SPECIAL USE REPORT

► FILE #: 9-B-21-SU AGENDA ITEM #: 26

► APPLICANT: WES CARRUTHERS

PROPOSED USE: Drive-Through Facility for an Eating and Drinking Establishment

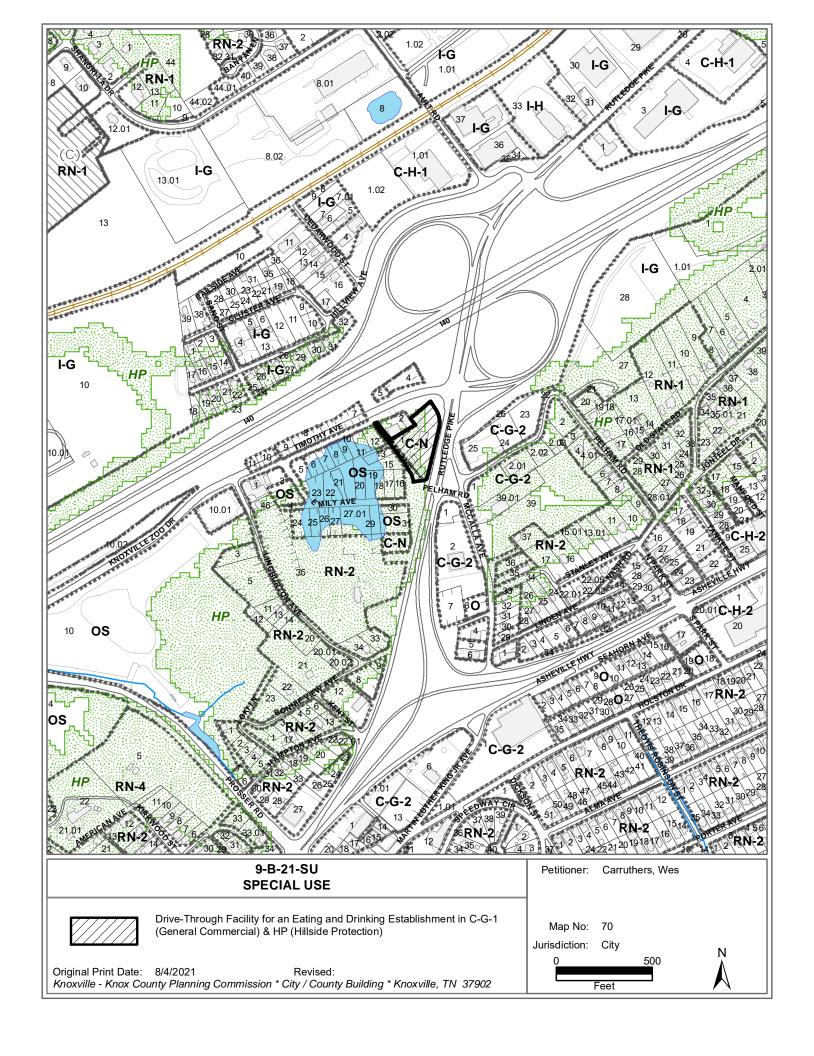
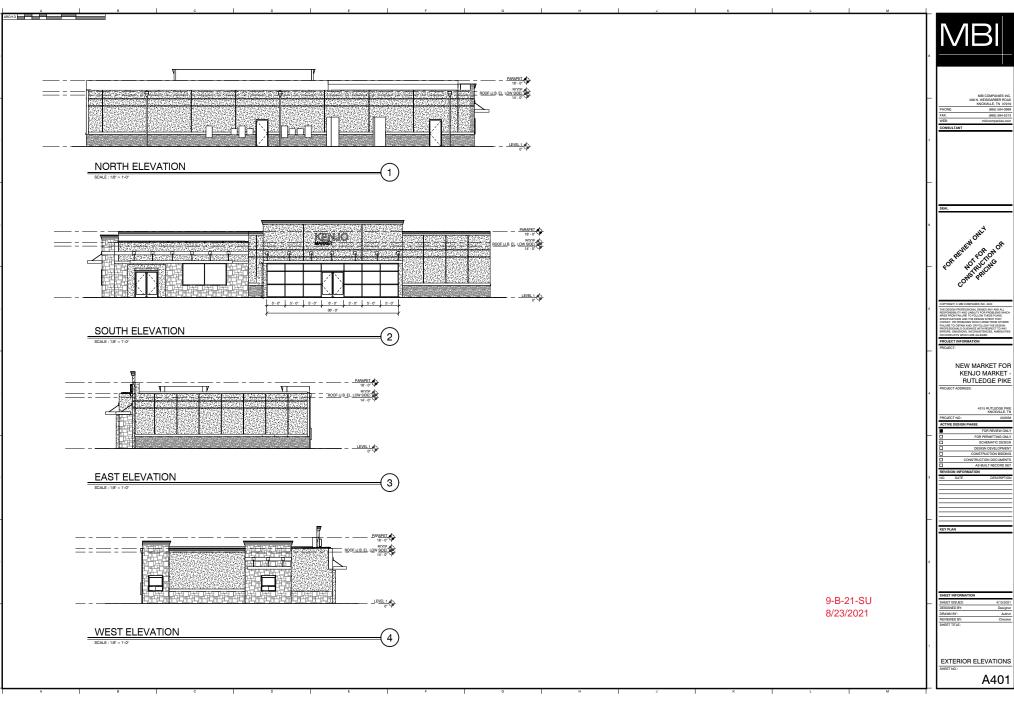
The parking lot has a proposed 6-ft setback from the Rutledge Pike right-of-way line, however, the minimum setback is 10-ft since the vehicular use area on the property is greater than 20,000 sqft. Terminal islands with 1 tree are also required at the end of each parking row. Landscaping must also be provided along 60 percent of the front building foundation. The drive aisle between the gas pumps and the parking in front of the building is larger than the minimum requirement. The additional area for the landscaping may be accommodated by reducing the width of the oversized drive aisle.

- A. The commercial buildings to the north were constructed very close to the shared property line with the subject site. The C-G-1 zone does not have a required rear setback when adjacent to non-residential uses, so

the proximity of the proposed retaining wall to the adjacent structures is permissible as long as all building code and engineering standards are met.

- 2. Meeting the requirements of Article 13 (Signs) of the City of Knoxville Zoning Ordinance.
- 3. Meeting the requirements of Article 11 (Off-Street Parking) of the City of Knoxville Zoning Ordinance, including but not limited to providing an accessible route from the main entrance to the public right-of-way and providing terminal islands at the end of parking rows.

- 4. Installation of landscaping per the requirements of Article 12 (Landscaping) of the City of Knoxville Zoning Ordinance, including but not limited to the required perimeter landscape yard along the Rutledge Pike frontage (Section 12.5), interior parking lot landscaping (Section 12.6), and site landscaping (Section 12.7).

- 6. Acquiring the excess right-of-way south of the property from the Tennessee Department of Transportation where the full access driveway and "future parking area" are located.

- 7. The "future parking area" shown on the south side of the property may be reviewed and approved by Planning Commission staff and the City of Knoxville Department of Engineering to confirm compliance with the zoning standards. The future parking area was not reviewed as part of this submittal because of the lack of detailed information.
